SUBJECT: Initial Draft of MIL-PRF-27/318C Amendment 1, MIL-PRF-27/319C Amendment 1, MIL-PRF-27/320C Amendment 1, MIL-PRF-27/321C Amendment 1, MIL-PRF-27/322E Amendment 1, MIL-PRF-27/323C Amendment 1, MIL-PRF-27/326C Amendment 1, MIL-PRF-27/328C Amendment 1; Project Numbers 5950-2017-020, -021, -022, -023, -024, -025, -026, -027.

MIL-PRF-27/323C
 AMENDMENT 1
DRAFT
 SUPERSEDING
 MIL-PRF-27/323C
 25 July 2008

TRANSFORMER, AUDIO FREQUENCY, TELEPHONE INTERCONNECT

FIGURE 1. Dimensions and configurations.

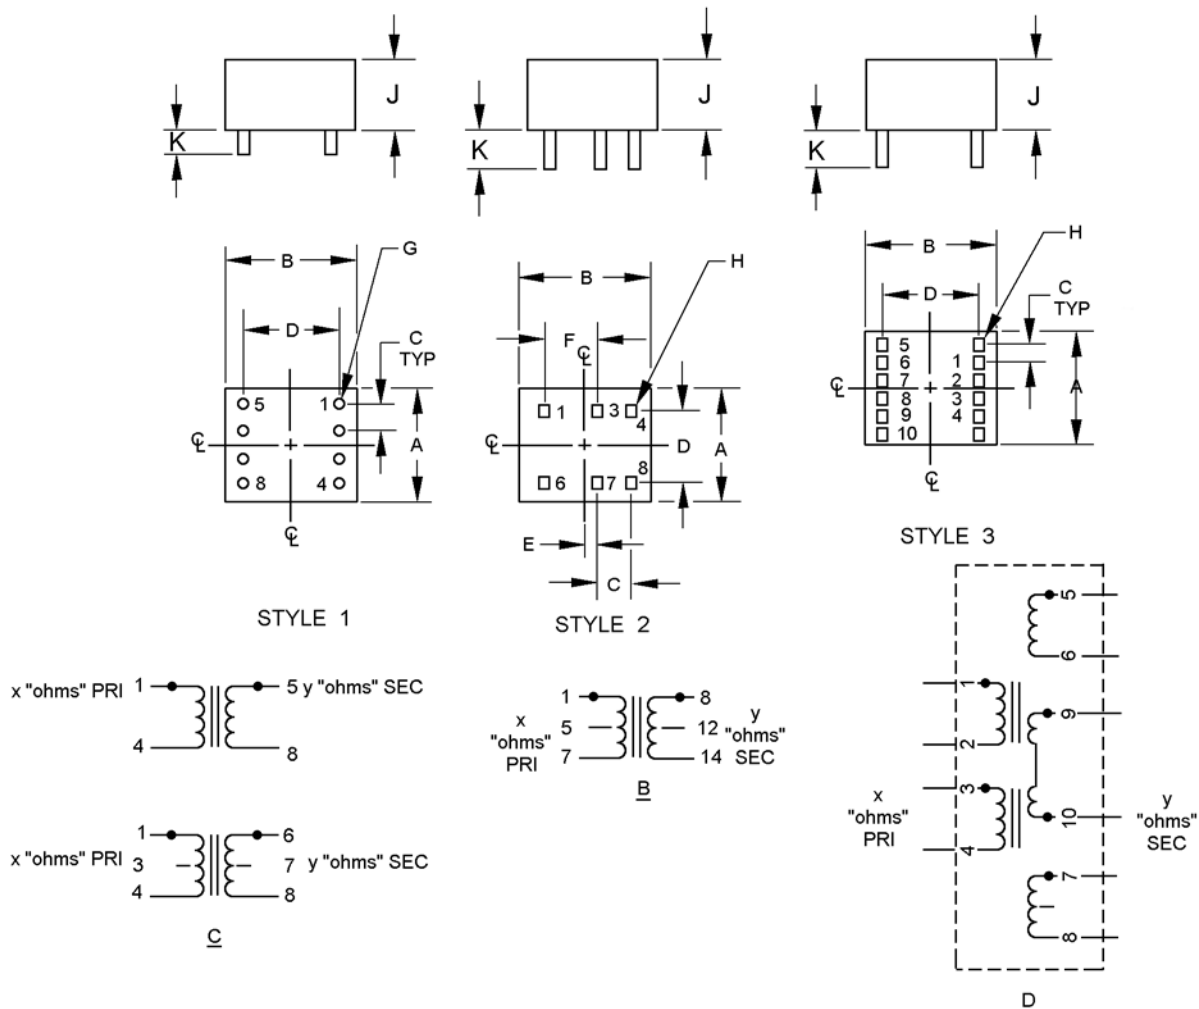
The proposed initial drafts are being amended to add a dimension table to Figure 1 instead of dimensions on the figures. This change will help to expedite further document actions.

Dash no.	A max.	B max.	J max.	C $\pm .010$	D $\pm .010$	E $\pm .010$	F $\pm .010$	G, Dia $\pm .005$	H, Sq. $\pm .005$	K, Pin Ht.	Weight oz. Max	Style
01	.875	1.093	.719	.20	.50	.13	----	.025	----	.125	1.2	1
02	1.562	1.875	.750	.25	1.00	.375	.75	----	.025	.156	3.7	2
03	1.562	1.875	1.156	.40	1.00	.20	.80	----	.025	.343	9.0	2
04	1.562	1.875	1.156	.40	1.00	.20	.80	----	.025	.343	9.0	2
05	1.562	2.812	1.156	.20	2.30	----	----	----	.025	.125	12.5	3
